PLANNING & ZONING COMMISSION AGENDA

PLANNING & ZONING COMMISSION
REGULAR MEETING
THURSDAY, February 14, 2019
9:00 AM

2. **PLN19-003**: A proposed rezoning of property at 300 N Montezuma Street and portions of Granite Creek Park to the north. Rezoning of Business Regional (BR) zoned City properties to Downtown Business (DTB). Rezoning of Natural Open Space (NOS) zoned City properties to Downtown Business (DTB) and Recreation Space (RS).

3. **PLN18-037:** Site Plan for Peaks View Apartments a 155-unit apartment complex and commercial development. Zoning: Business Regional (BR); Property owner: Lafferty Development. Site APNs: 103-15-160A and 165. Location: 4822 E State Route 69.

BUILDING ELEVATIONS

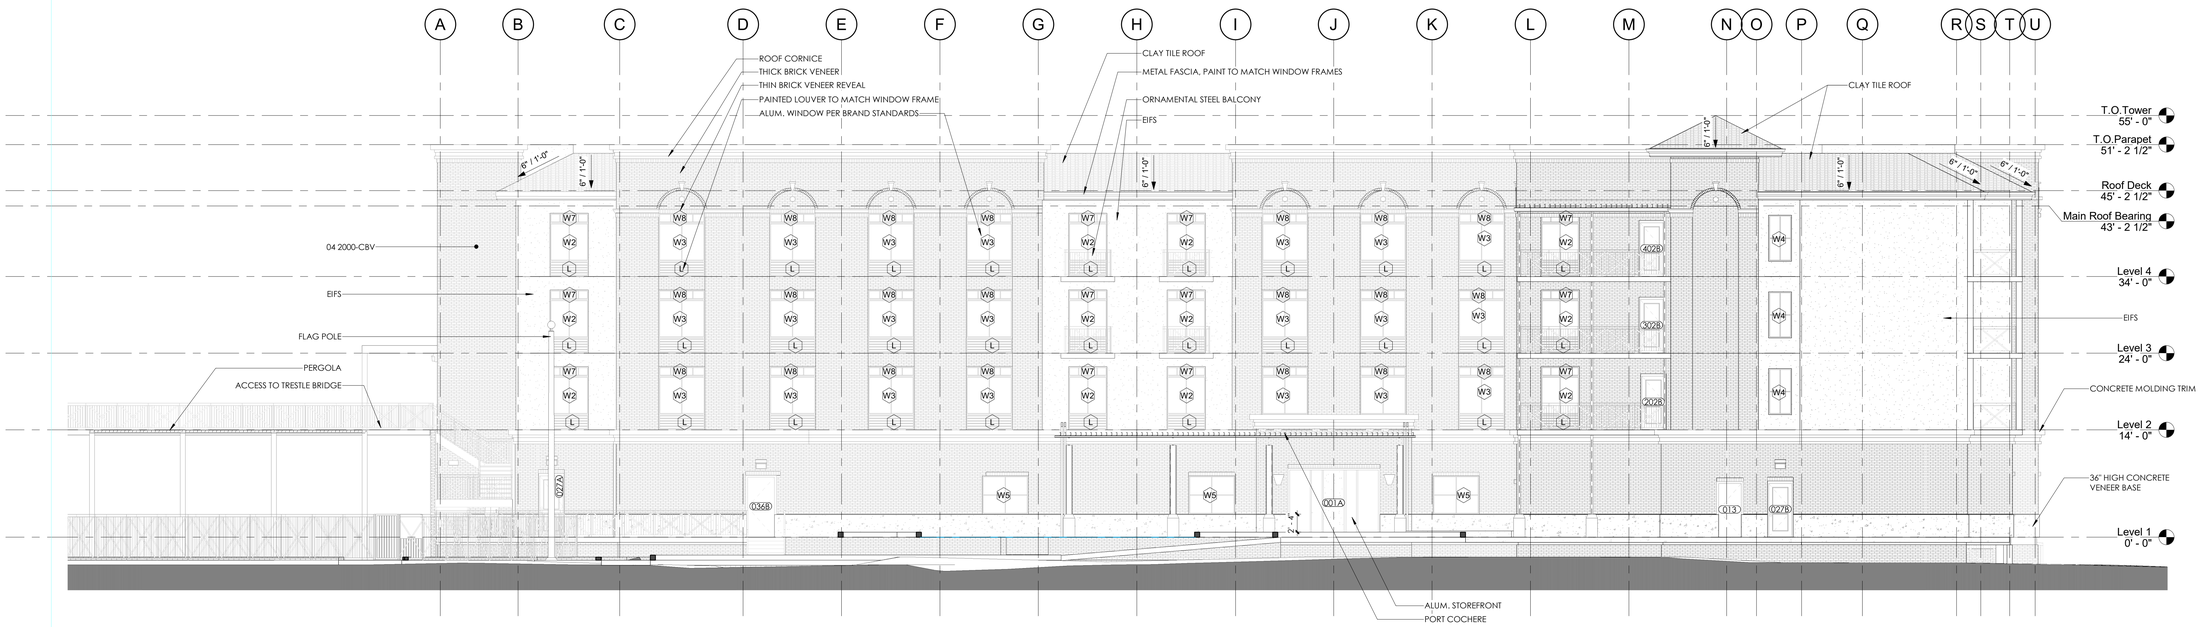
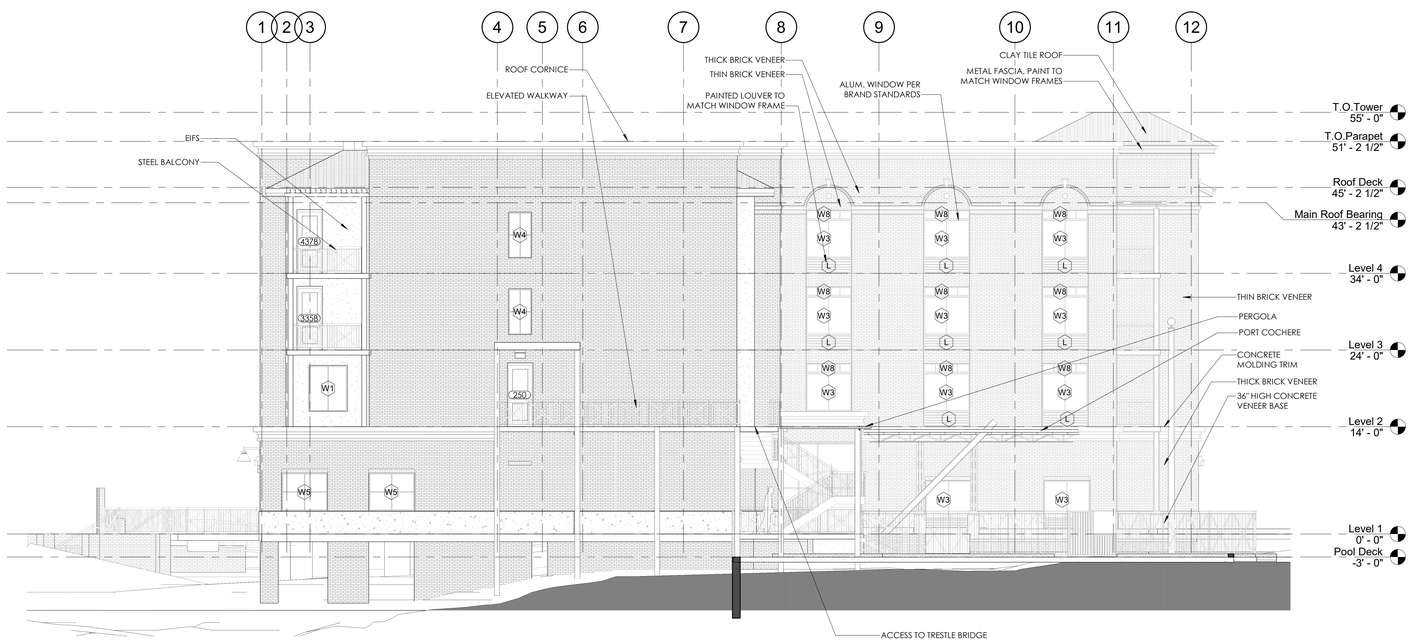
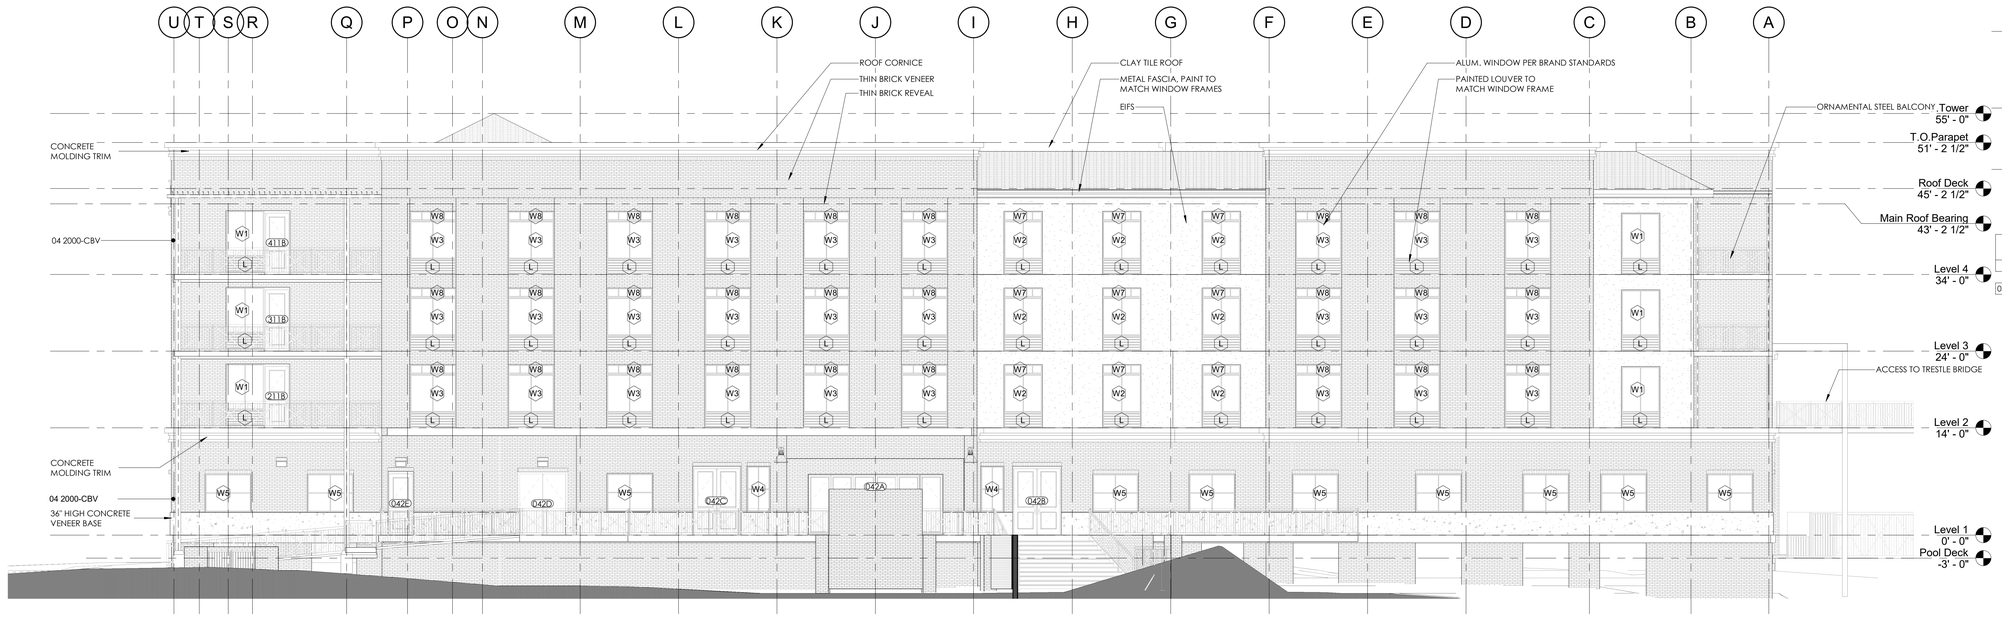
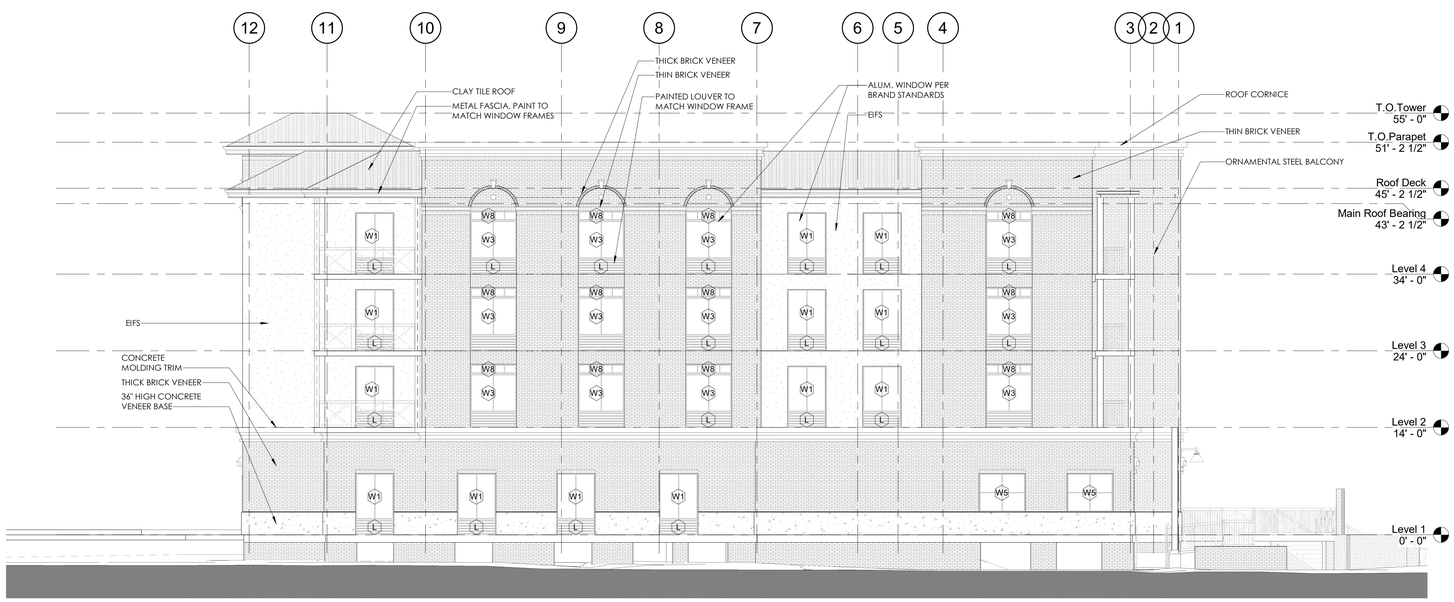
Councilman Goode expressed concerns about contract language and water use and the ability to assess usage and future needs at the hotel. He also expressed concern about the setback on Montezuma and Sheldon, wondering if there is a way the project could be visually softened.

Commissioner Mabarak stated he feels the building is too high and being right on the street is a concern. He likes the zoning and the use, but the setback is a concern. He would like to see a better presence on Montezuma to the public.

Commissioner Roop mentioned different approaches such as stair stepping the building away from Montezuma.

The hotel building is proposed to be four stories, with a total guest room count of 100. The design will include architectural features from a number of iconic structures in the downtown. The nearby railroad trestle features strongly in the design. Other common features of downtown buildings, such as extensive use of brick in the façades and a window pattern similar to existing historic buildings, are also included. The building will be below the height of many of the nearby trees in Granite Creek Park, a feature that will reduce visual impacts to nearby properties. An elevation rendering is attachment 5 of this report.

1 PROPOSED SITE PLAN

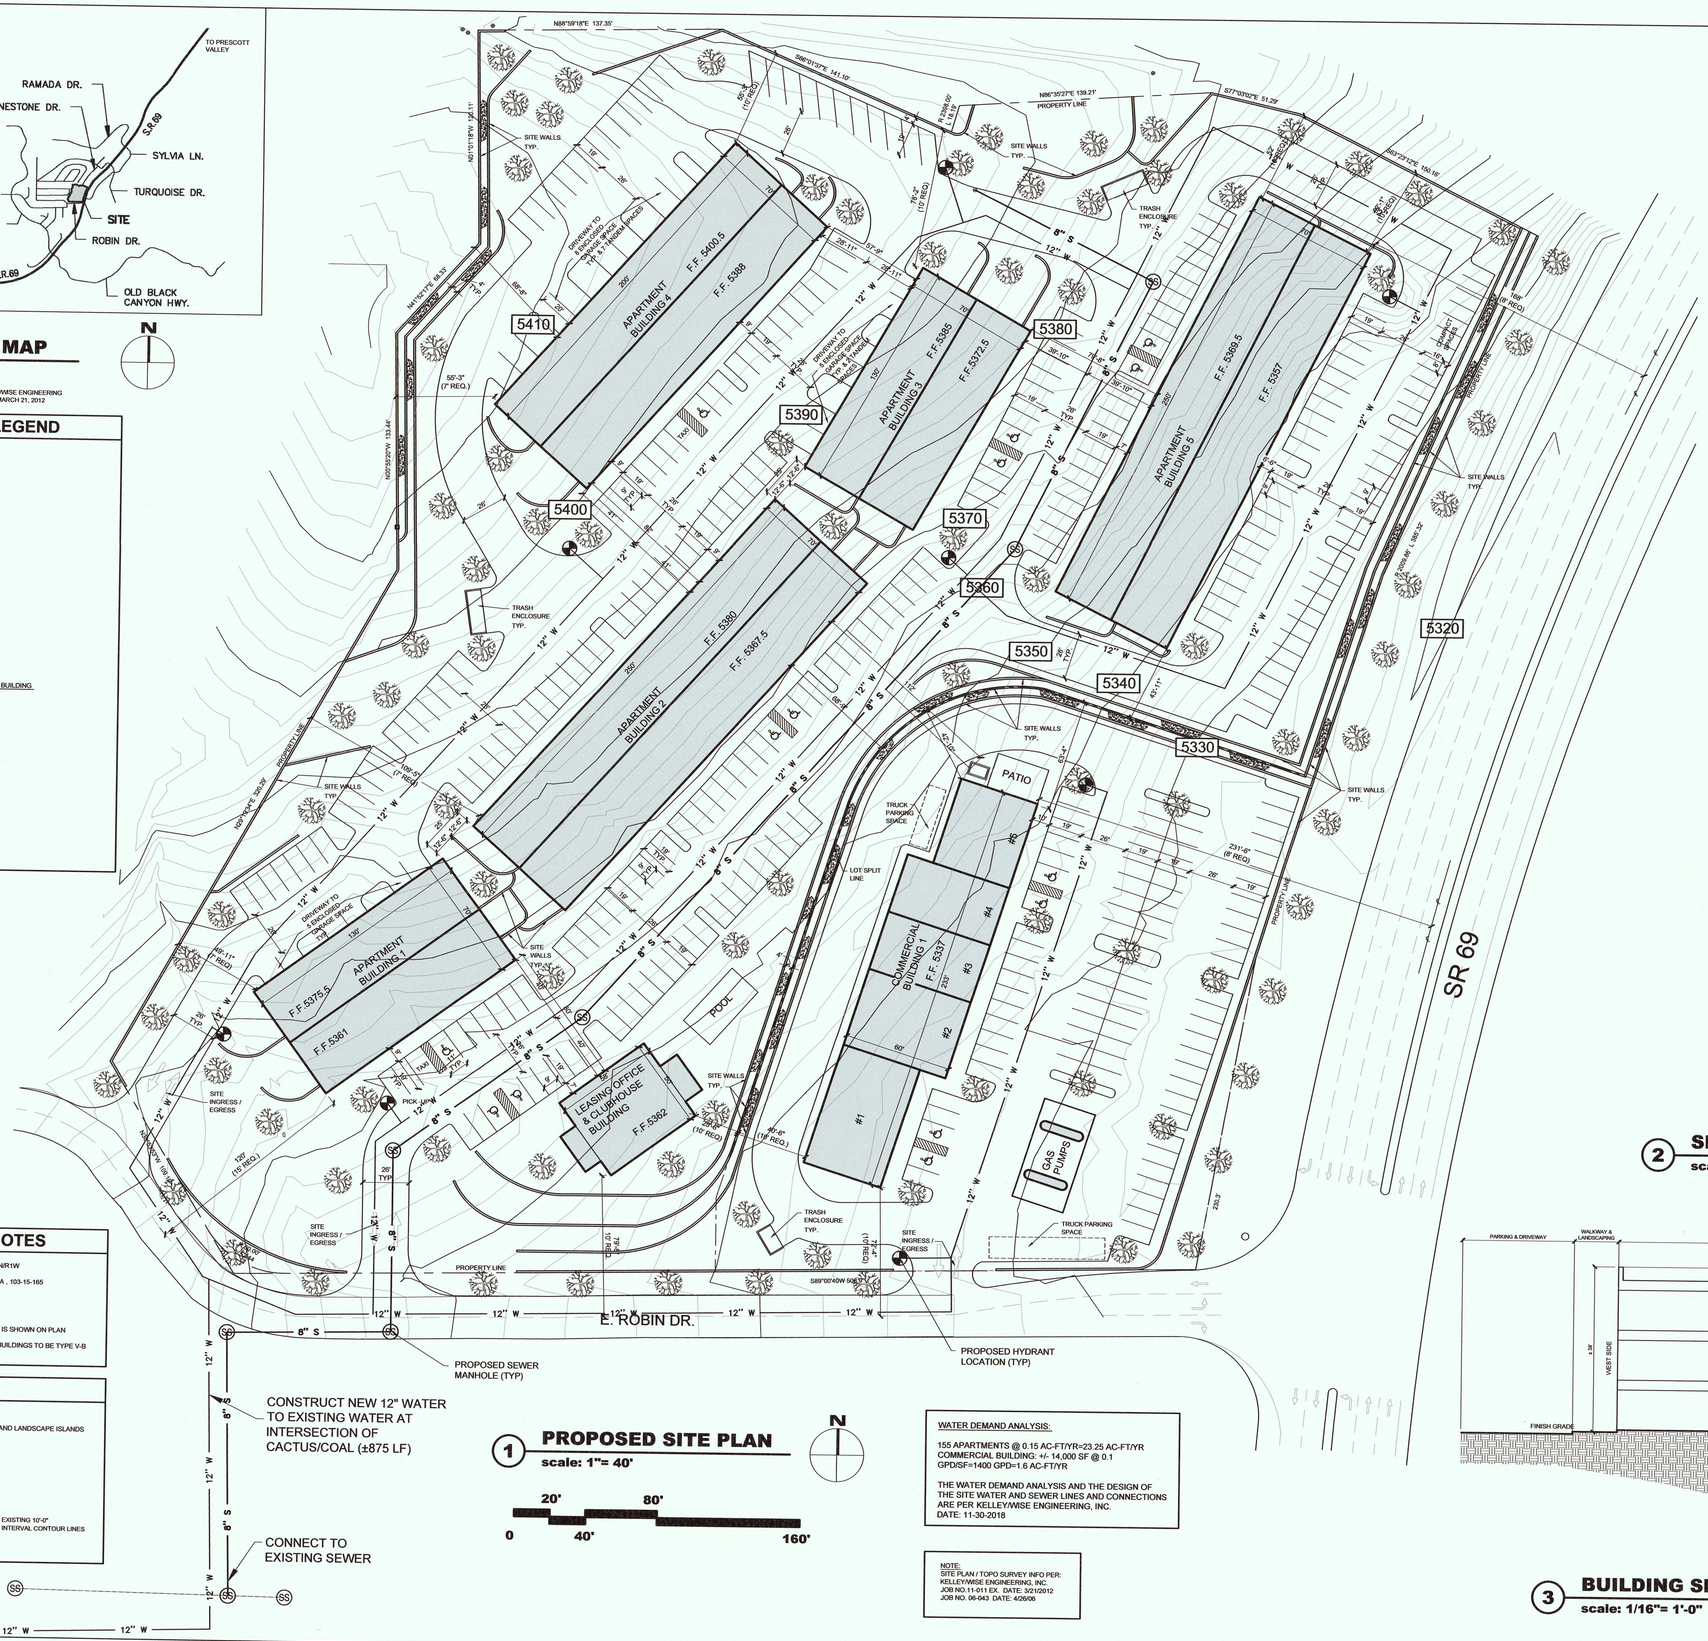
Minimum setbacks required for the residential development are 15 feet front, 10 feet rear and 12 feet for the sides. Setbacks for the commercial development are 10 feet front, 10 feet rear and 12 feet for the sides. The site plan depicts significantly greater setbacks for all sides of the site than is required by the Land Development Code.

Parking for the residential use is determined by the number of bedrooms proposed, plus a fixed 20 guest parking spaces. The proposed plan indicates 80 1-bedroom units, 50 2-bedroom units and 25 3-bedroom units. Based on this mix, the residential portion of the development will require 278 parking spaces. The site plan indicates 280 parking spaces will be provided for the residential complex. The commercial portion of the development will require approximately 77 spaces, based upon the anticipated mix of uses. The site plan indicates that 84 spaces will be provided for the commercial portion of the site.

The BR district allows building heights of up to 50 feet. The residential buildings are shown at approximately 40 feet in height. The site is proposed to be graded in terraces from (roughly) east to west down to the road grade of State Route 69 at the commercial portion. The terracing will result in the buildings being 3-stories from each of the adjacent parking areas. The commercial buildings will be 1-story, with overall heights well under the 50 foot maximum height permitted.

Access to the site is to be limited to three points on Robin Drive. The commercial site will have 1 access approximately 100 feet from the intersection with State Route 69. The residential site will have 2 access points, the first at roughly 450 feet from the intersection and the second at roughly 400 feet further west around the first curve of Robin Drive.

Based upon the information provided on the site plan, staff has determined that this plan is in conformance with the requirements of the Land Development Code.
